SUBJECT: ISSUANCE OF AMENDMENT NO. 71 TO FACILITY OPERATING LICENSE  
NO. NPF-11 AND AMENDMENT NO. 55 TO FACILITY OPERATING LICENSE  
NO. NPF-18 - LASALLE COUNTY STATION, UNITS 1 and 2 TAC NOS.  
(74516/74517)

The amendments revise the LaSalle County Station, Units 1 and 2, Technical Specification 3/4 4.6 regarding pressure - temperature limits of the Reactor Coolant System in order to comply with Generic Letter 88-11 and Regulatory Guide 1.99, Revision 2.

Amendment No. 71  
License No. NPF-11

Amendment No. 55  
License No. NPF-18

Figure 3.4.6.1-1

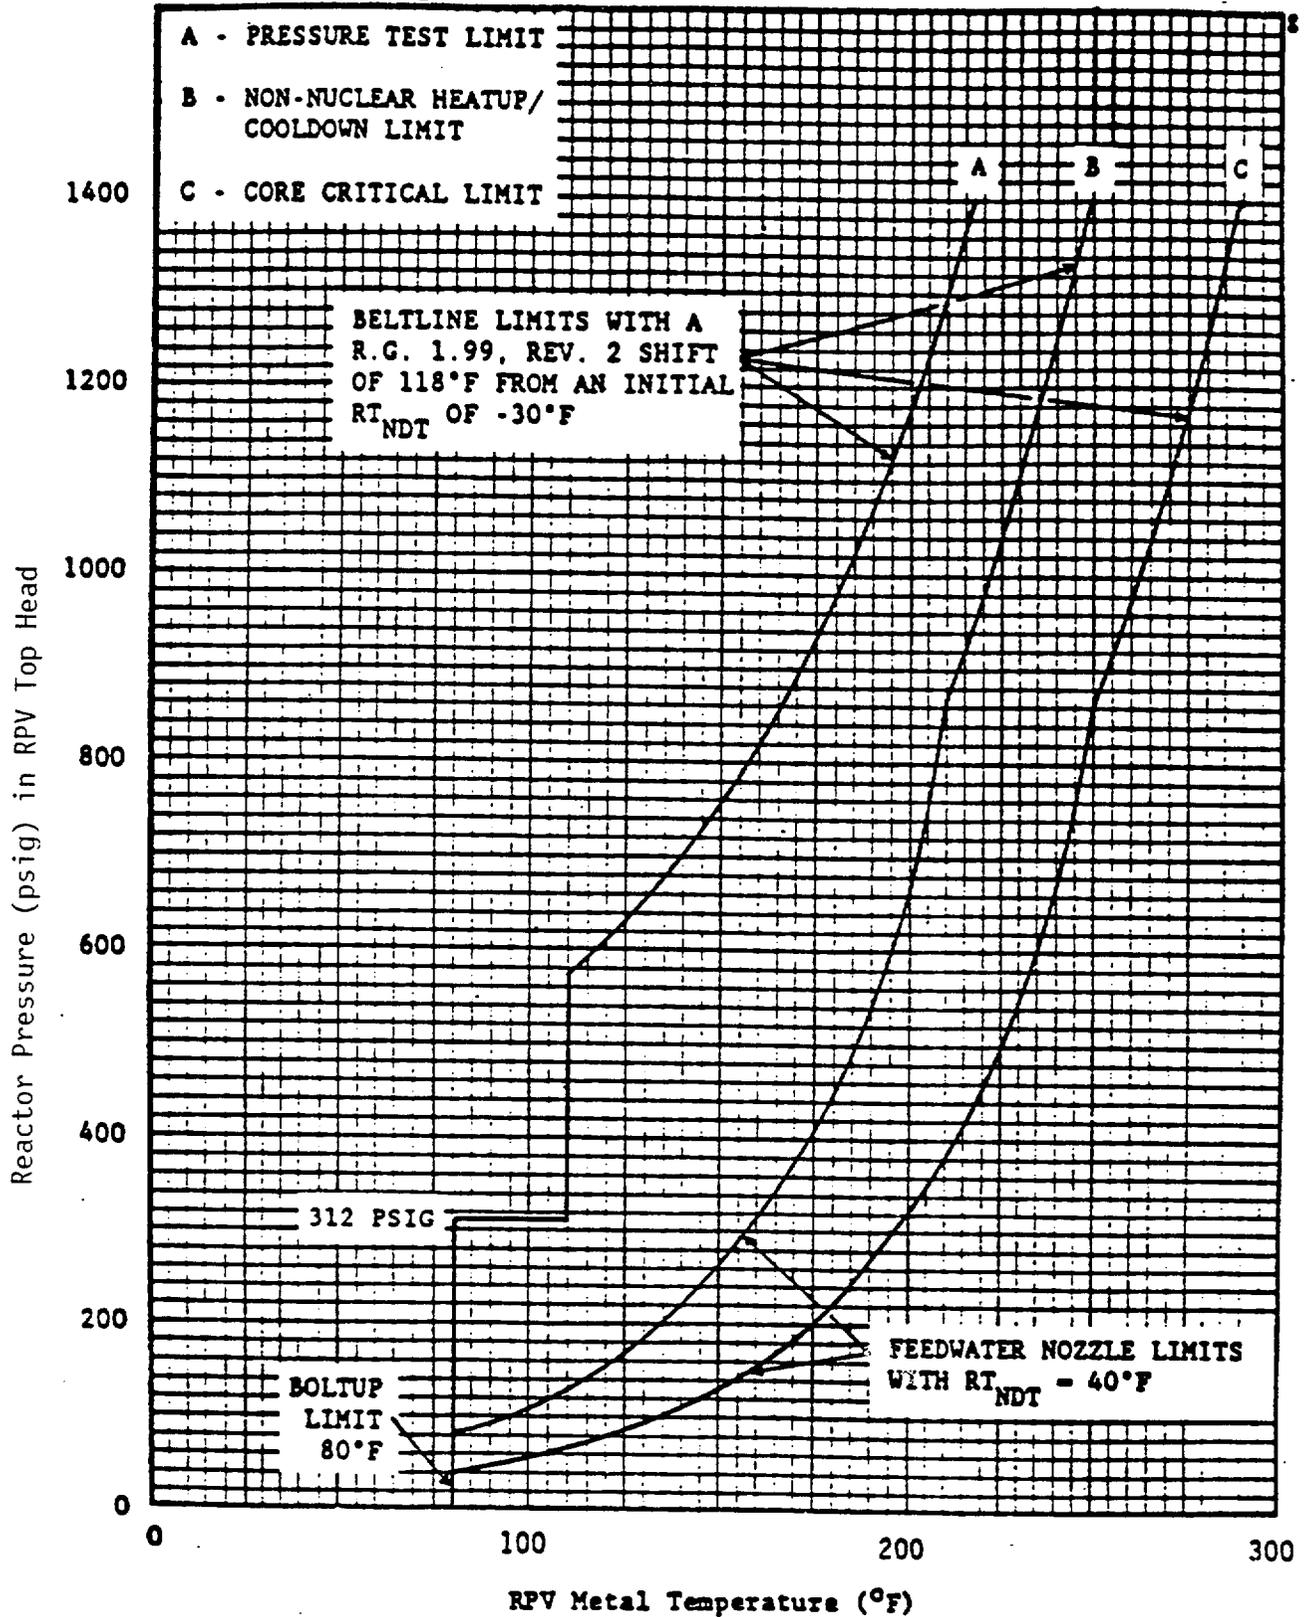
3.4.6.1 The reactor coolant system temperature and pressure shall be limited in accordance with the limit lines shown on Figures 3.4.6.1-1 and 3.4.6.1-1a (1) curves A for hydrostatic or leak testing; (2) curves B for heatup by non-nuclear means, cooldown following a nuclear shutdown and low power PHYSICS TESTS; and (3) curves C for operations with a critical core other than low power PHYSICS TESTS, with:

4.4.6.1.3 The reactor vessel material specimens shall be removed and examined to determine reactor pressure vessel fluence as a function of time and THERMAL POWER as required by 10 CFR Part 50, Appendix H in accordance with the schedule in Table 4.4.6.1.3-1. The results of these fluence determinations shall be used to update the curves of Figures 3.4.6.1-1 and 3.4.6.1-1a.

The pressure-temperature limit lines shown in Figures 3.4.6.1-1 and 3.4.6.1-1a for reactor criticality and for inservice leak and hydrostatic testing have been established using the requirements of Appendix G to 10 CFR Part 50 for reactor criticality and for inservice leak and hydrostatic testing, General Electric "Transient Pressure Rise Affecting Fracture Toughness Requirement for Boiling Water Reactors," NEDO-21778-A, December 1978, and "Protection Against Non-Ductile Failure" of the ASME Boiler and Pressure Vessel Code, 1971 Edition, including Summer 1972 Addenda.

Figure 3.4.6.1-1

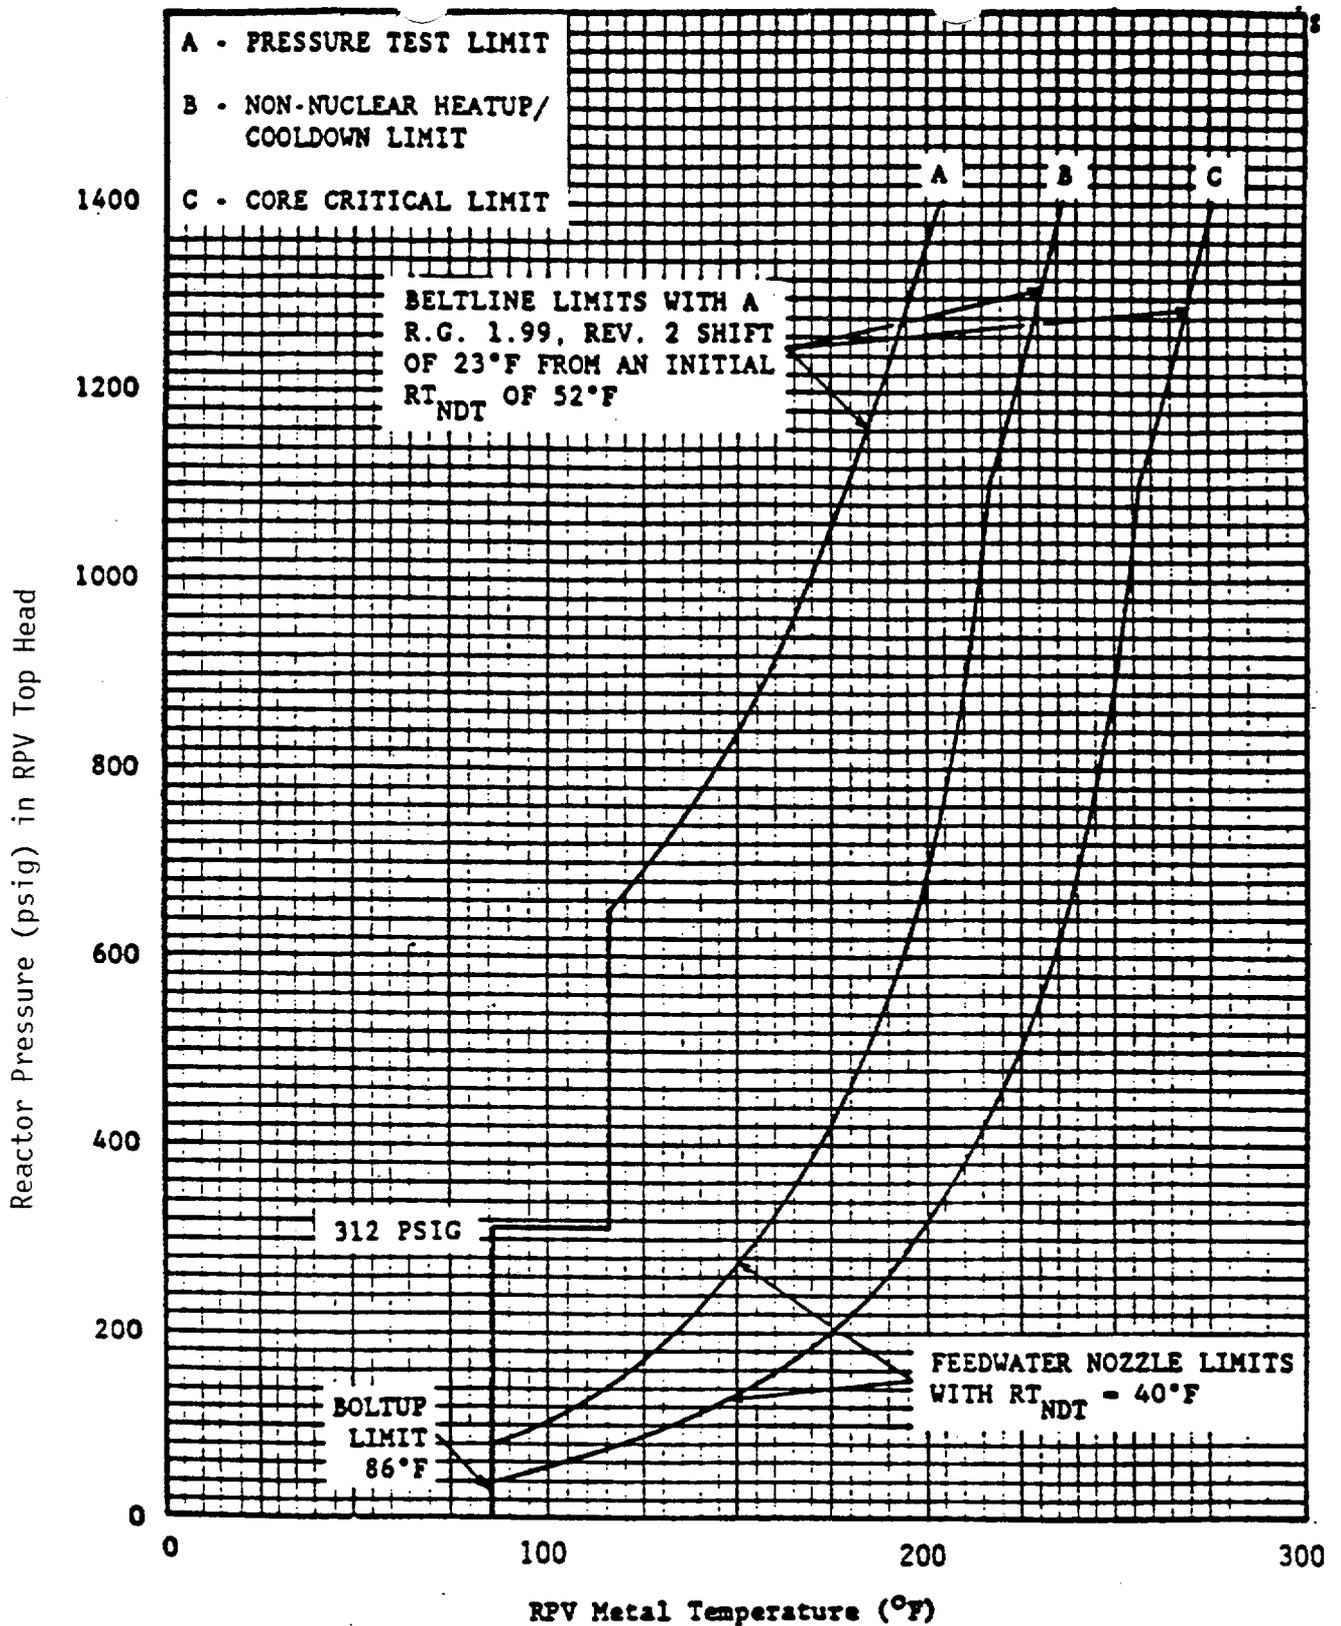
3.4.6.1 The reactor coolant system temperature and pressure shall be limited in accordance with the limit lines shown on Figures 3.4.6.1-1 and 3.4.6.1-1a; (1) curves A for hydrostatic or leak testing; (2) curves B for heatup by non-nuclear means, cooldown following a nuclear shutdown and low power PHYSICS TESTS; and (3) curves C for operations with a critical core other than low power PHYSICS TESTS, with:

4.4.6.1.3 The reactor vessel material specimens shall be removed and examined to determine reactor pressure vessel fluence as a function of time and THERMAL POWER as required by 10 CFR Part 50, Appendix H in accordance with the schedule in Table 4.4.6.1.3-1. The results of these fluence determinations shall be used to update the curves of Figures 3.4.6.1-1 and 3.4.6.1-1a.

The pressure-temperature limit lines shown in Figures 3.4.6.1-1 and 3.4.6.1-1a for reactor criticality and for inservice leak and hydrostatic testing have been established using the requirements of Appendix G to 10 CFR Part 50 for reactor criticality and for inservice leak and hydrostatic testing, General Electric "Transient Pressure Rise Affecting Fracture Toughness Requirement for Boiling Water Reactors," NEDO-21778-A, December 1978, and "Protection Against Non-Ductile Failure" of the ASME Boiler and Pressure Vessel Code, 1971 Edition, including Summer 1972 Addenda.
